**Third Interim Collection
1991-1993 NESC Interpretations**

**Third Interim Collection
of the
National Electrical Safety Code
Interpretations**

1991-1993

Fig IR 458

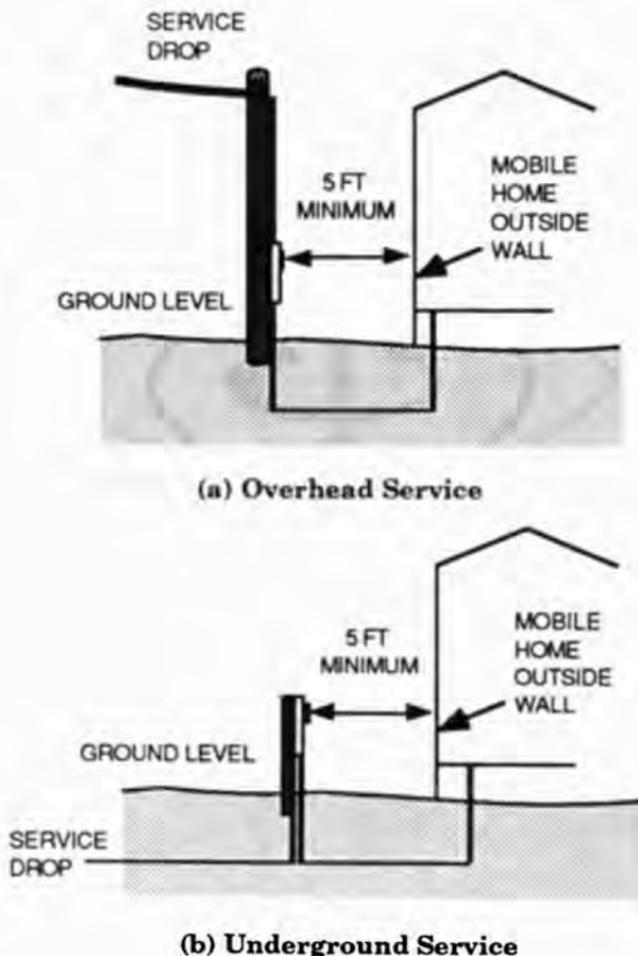
Figure IR 458-1(a) shows an overhead service. The co-op line comes only to the top of the pole and ties to the customer-supplied service cable that runs to the meter base and disconnect.

Figure IR 458-1(b) shows an underground service. The co-op supplies the electric line and any necessary conduit into the bottom of the meter base and disconnect, which is customer-supplied.

Is there a 5 ft requirement between a customer-supplied service disconnect and meter base as described above and the side of a mobile home?

The NESC does not cover clearance from the side of a mobile home to a

Assuming that the service drop in this case is the typical 120/240 V Rule 230C3 cable, Table 234-1 requires a horizontal clearance of 5 ft to buildings. However, this horizontal clearance applies only if required vertical or transitional clearance is not met. In other words, the horizontal clearance does not apply if the service pole is tall enough to provide required vertical clearance above the roof of the mobile home.

Electric supply utilities may establish rules that exceed NESC requirements. However, the NESC does not require 5 ft clearance from a customer-supplied service disconnect and meter base to the side of a mobile home.

Fig IR 454-1
Top View

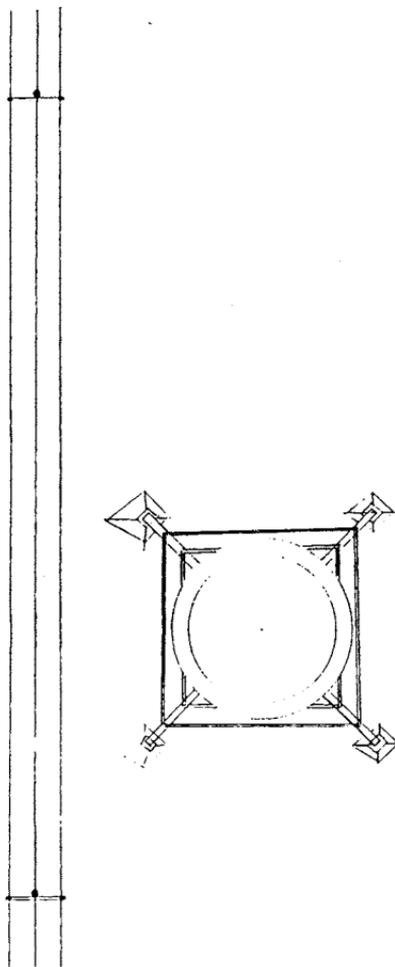
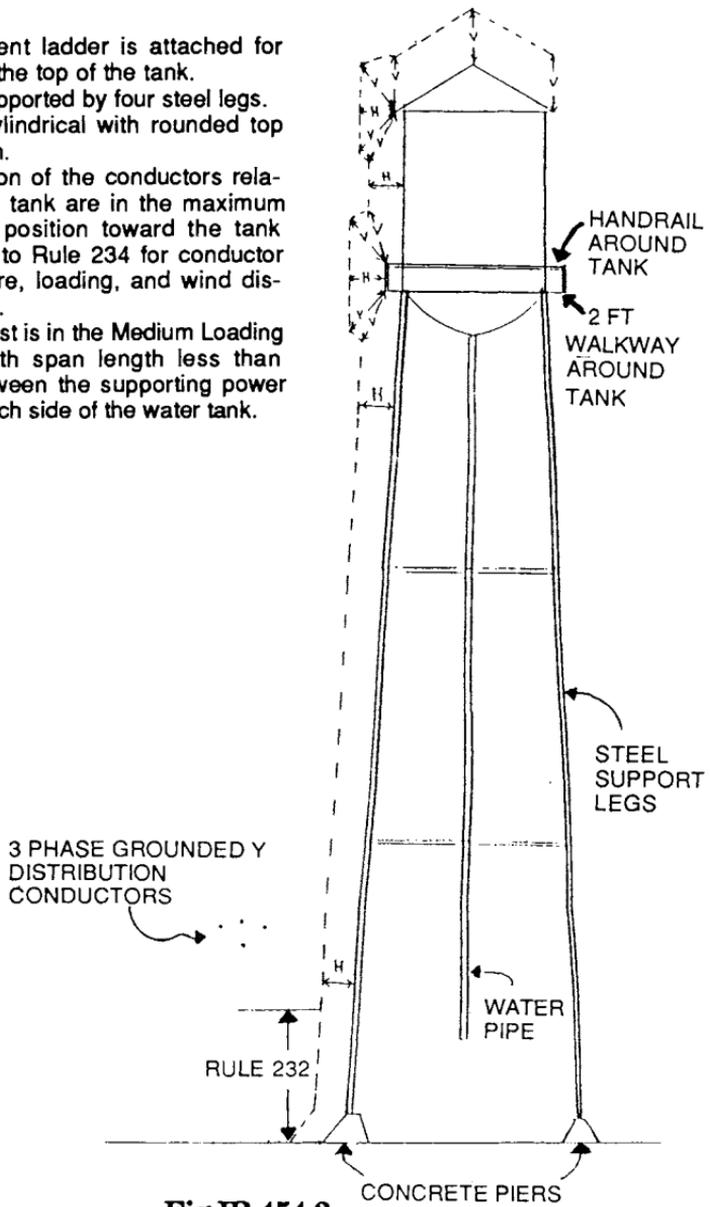
The tanks are constructed similar to Figs IR 454-1 and 454-2 (see pp. 20-21) with four metal legs supporting the tanks. The horizontal distance between legs is greater at the ground than at the tank. In any of our tank locations (as represented in the figures) the horizontal distance clearance requirement and the diagonal distance from the conductor to the nearest point on the structure is greater than the vertical clearance requirement of Table 234-1. Also, the conductors are higher above ground than the code requirement by Table 232-1.

Our understanding of the clearance envelope is indicated on the attached drawing; however, the code is not clear in Section 234C as to how the horizontal requirement should be applied to a side of the water tank support leg that has a slight lean such as is the case on our attached drawing. Also, the Clearance Diagrams for Building and Other Structures in Figure 234-1 do not address our specific concern. In each of these clearance diagrams the horizontal measurement is from a vertical surface. Should the horizontal measurement be made horizontally from the conductor to the

leaning support leg or perpendicular to the support leg out to the conductor?

Rule 234C specifies vertical and horizontal clearances to buildings and similar installations. These vertical and horizontal clearances are to be applied in the appropriate vertical or horizontal plane, *not* perpendicular to a sloping surface.

Application of vertical clearances required by Rule 234C to sloping surfaces is illustrated in Fig 234-1. Horizontal clearances to sloping surfaces are applied in the same manner, horizontally to the surface.

Note 4 in your request for interpretation states that the conductors shown in the side view are in the maximum displaced position toward the tank. Horizontal clearances shown in Table 234-1 are for conductors at rest (no wind displacement) under the conditions specified in Rule 234A1; see Rule 234C1a. Certain supply conductors must also meet the clearances shown in Rule 234C1b when displaced by wind. Open wire supply conductors in the voltage range you specified in the first paragraph of your request must meet *both* conditions.

Figs IR 465-1 and IR 465-2

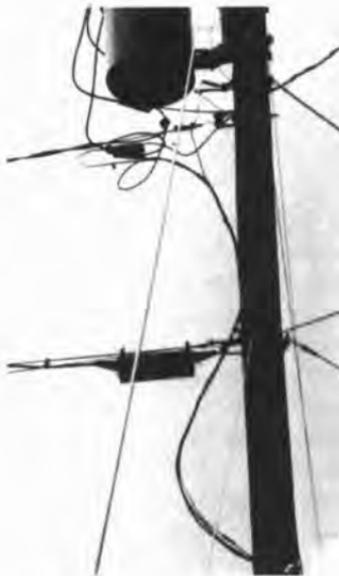
The enclosed photographs (Figs IR 465-1-465-6) depict typical temporary power installations throughout the area concerned consisting of triplex conductors suspended freely from the transformer secondary splice to the weatherhead placed toward the bottom of the pole. As you can see, the conductors are somewhat loose in the climbing space and, according to some, create a considerable exposure hazard to those climbing with "hooks." One photo (Fig IR 465-3) exhibits an attempt by a communications worker to tie back the triplex so that it would not be adjacent to his working area on the pole.

3. Are the construction methods depicted in Figs IR 465-1–465-6 in accordance with NESC rules and regulations?
